# Product/Process Change Notice (PCN)

PCN #: ConCRD\_20150902  
 Product Affected: 693012040811

PCN Date: September 16<sup>th</sup>, 2015  
 Effective Date: December 16<sup>th</sup>, 2015

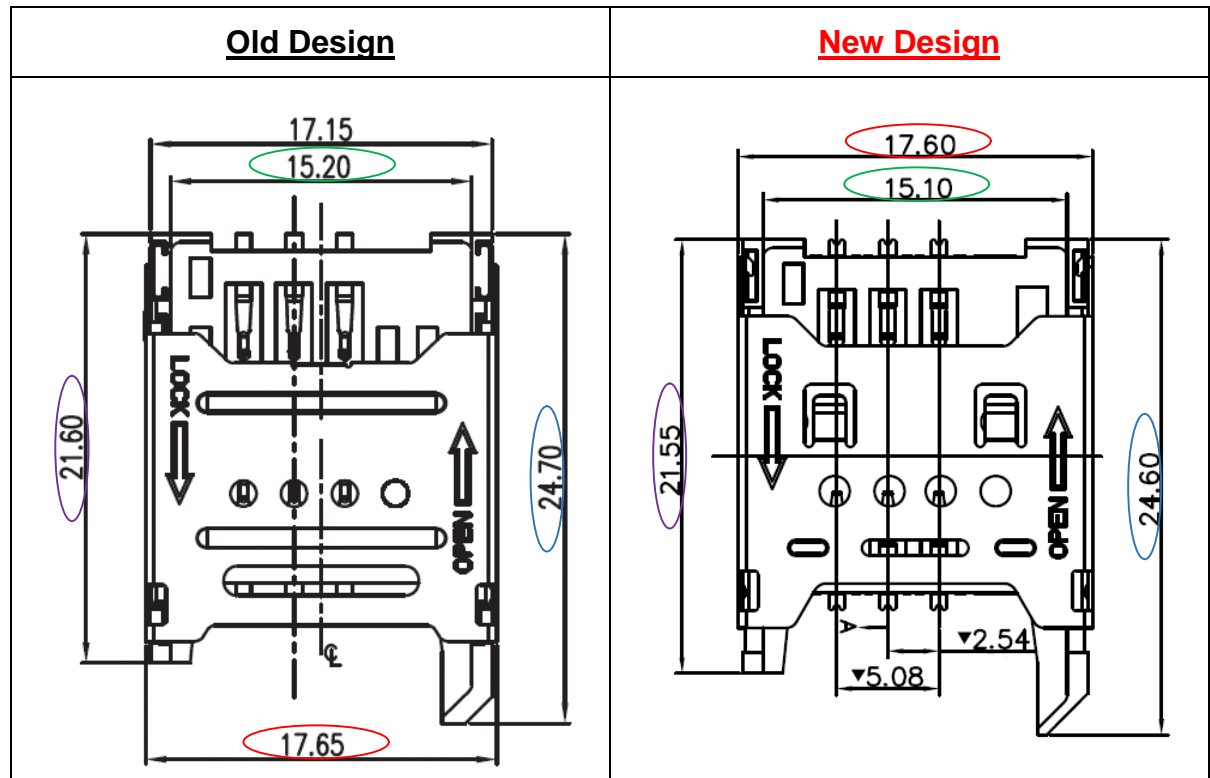
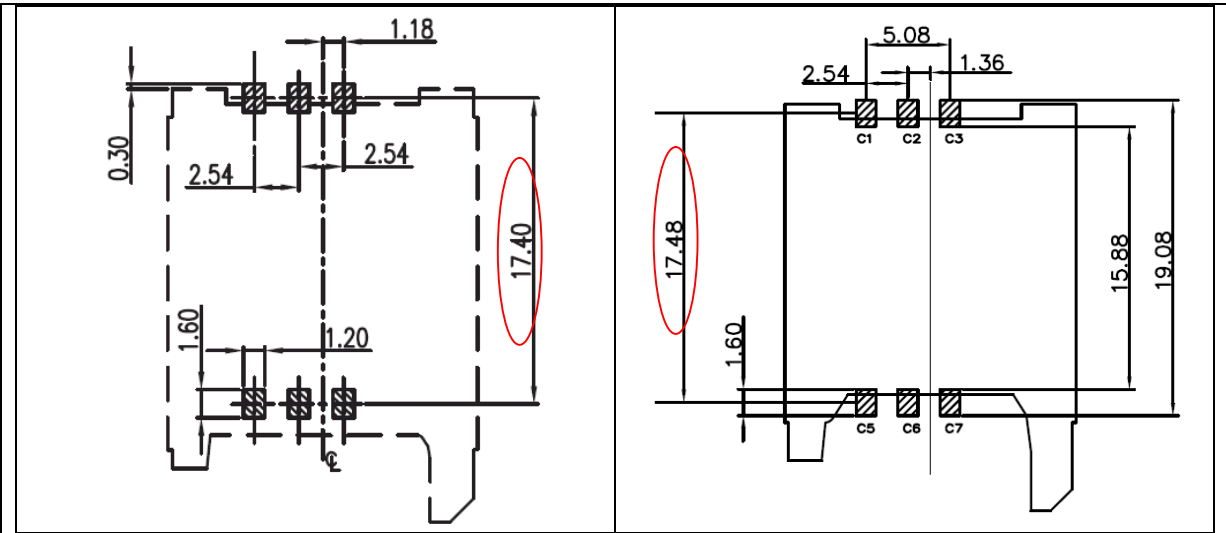
In order to optimize the hinge mechanism, Würth Elektronik will modify the mold design. Both insulator and shielding have been changed to fit better with customers' requirements. This new version of product is layout compatible with the expired one in order to maintain compatibility between versions.

The design changes are summarized below and marked in colour:
